Council Ref: DA205/15
(LD) (CIS)

RE: SCECGS Redlands School Concept Proposal and Stage 1 Development
Your Ref: SSD 6454

North Sydney Council has reviewed the '*Response to Submissions*' provided by the Applicant and wish to make the following comments:

Figure 1 – Extract from Height of Building Map in NSLEP 2013

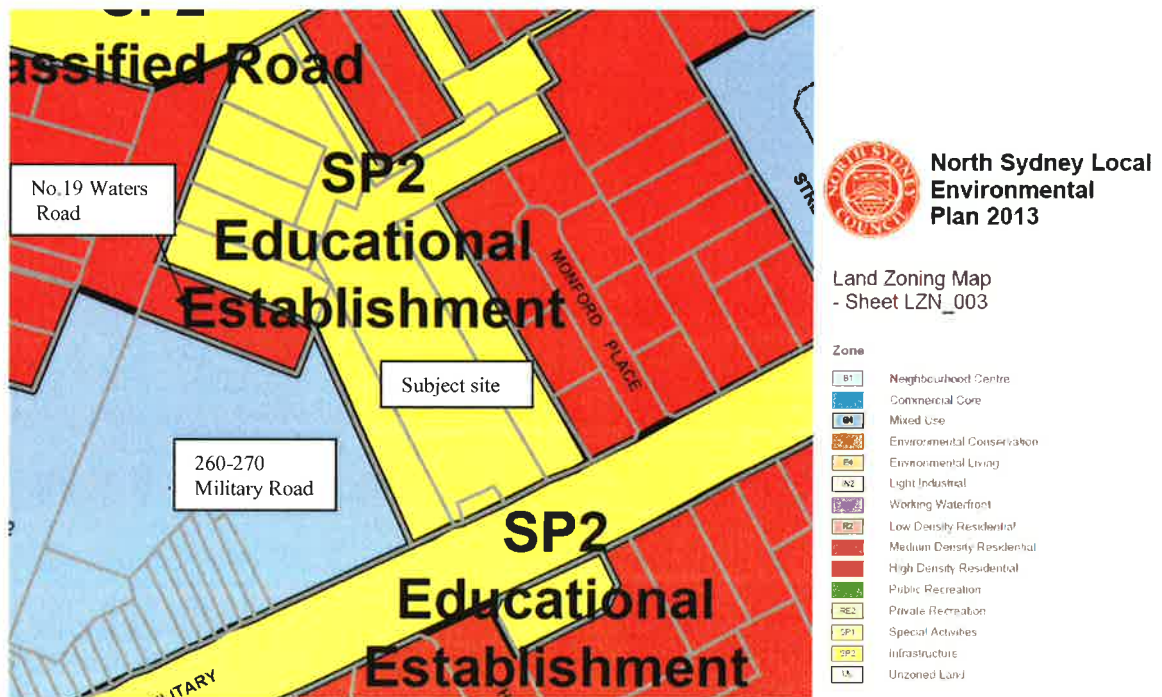
Clause 4.3(3) of NSLEP 2013 states that the maximum permitted building height on the site is 12 metres. North Sydney Council acknowledges that some amendments have been made to the building envelope and heights of the proposed New Sports Hall and Drama Building (Stage 2) and the New Humphreys Building (Stage 4). Notwithstanding, North Sydney Council is of the firm view that the scale of the New Humphreys Building (Stage 4) being a maximum of 22.4m is still incompatible with the sites adjoining and opposite along Waters Road that are zoned R4 High Density Residential with a maximum permissible building heights of 12m (**refer to Figures 1 and 2 below**).

The New Humphreys Building (Stage 4) is proposed at a building height of between 14.1m (RL91.64) and 22.4m (RL99.24) which is significantly higher than maximum building heights (12m) permissible on sites adjoining (No.19 Water Road) and opposite (No's 26, 28 and 30 Water Road).

The significant non compliances with the height control for this building is contrary to the Aim of Plan 1.2(2)(b)(i) and building height objectives 4.3(1)(c), (e) and (f) of NSLEP 2013 which seek to:

A further reduction in the scale of the New Humphreys Building (Stage 4) and a greater setback from the western boundary of the site would significantly improve solar access, particularly between the critical hours of 10.30am and 12noon during winter solstice, to the ground floor living rooms of the townhouses at No.19 Water Road.
